Replacement Requirement for Pressure Sensors for Refrigerant Circuit - Mixed Installation Not Permitted (70/24)

Vehicle Type: **Cayenne Turbo E-Hybrid (9YA/9YB)/ Cayenne Turbo S E-Hybrid (9YA/9YB)/ Cayenne Turbo E-Hybrid Coupé with GT Package (9YB)**

Concerns: **Refrigerant circuit pressure sensors**

Pressure sensor part identifier

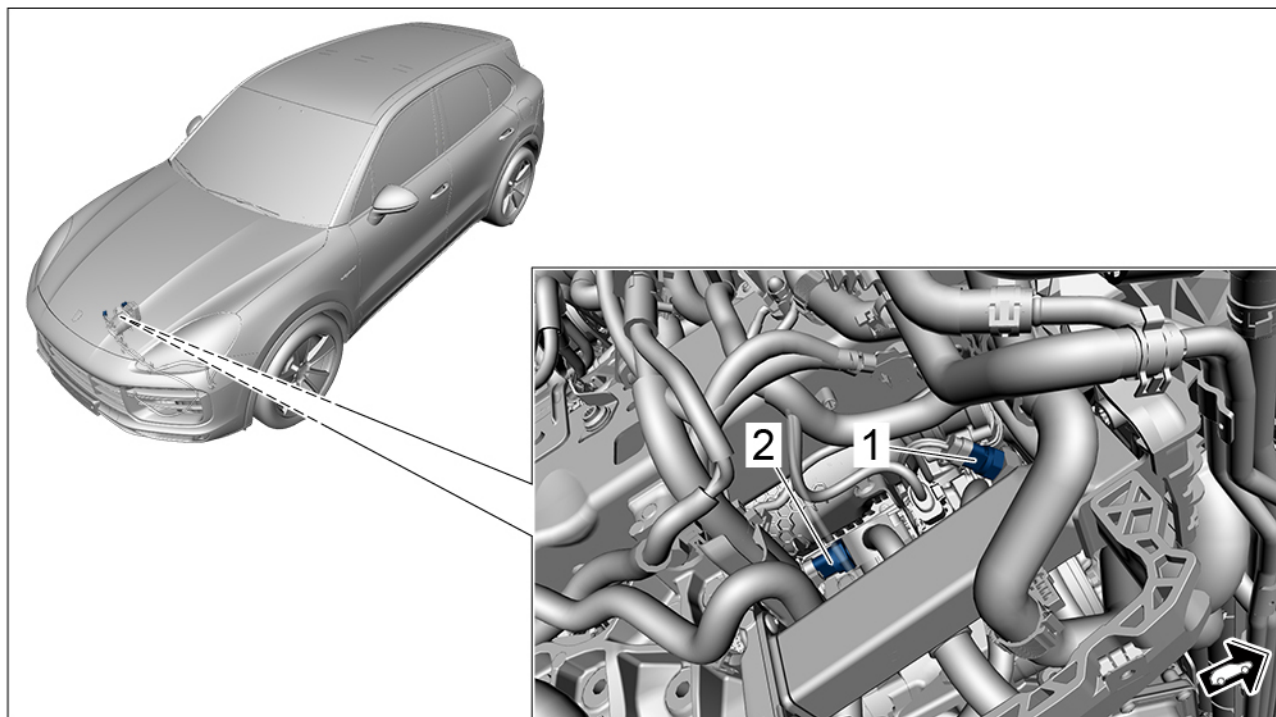
Cause: **Due to the discontinuation of an electronic component within the pressure sensor, the pressure sensors for the refrigerant circuit have been switched to a changed component status.**

Pressure sensors that correspond to the changed component status are not compatible with the previous pressure sensors.

If a pressure sensor is required for replacement, it must therefore be ensured that both pressure sensors in the refrigerant circuit correspond to the changed component status (identical part number). If this is not the case, the respective other pressure sensor must also be replaced as a one-off. Mixed installation of pressure sensors with different component status (mixed installation) is not technically permissible and leads to faults in the refrigerant circuit and in the air conditioning.

Action: If a pressure sensor must be replaced, ensure that both pressure sensors in the refrigerant circuit correspond to the changed component status with the part identifier 4M0959603J.

If this is not the case, **both** pressure sensors must be replaced.
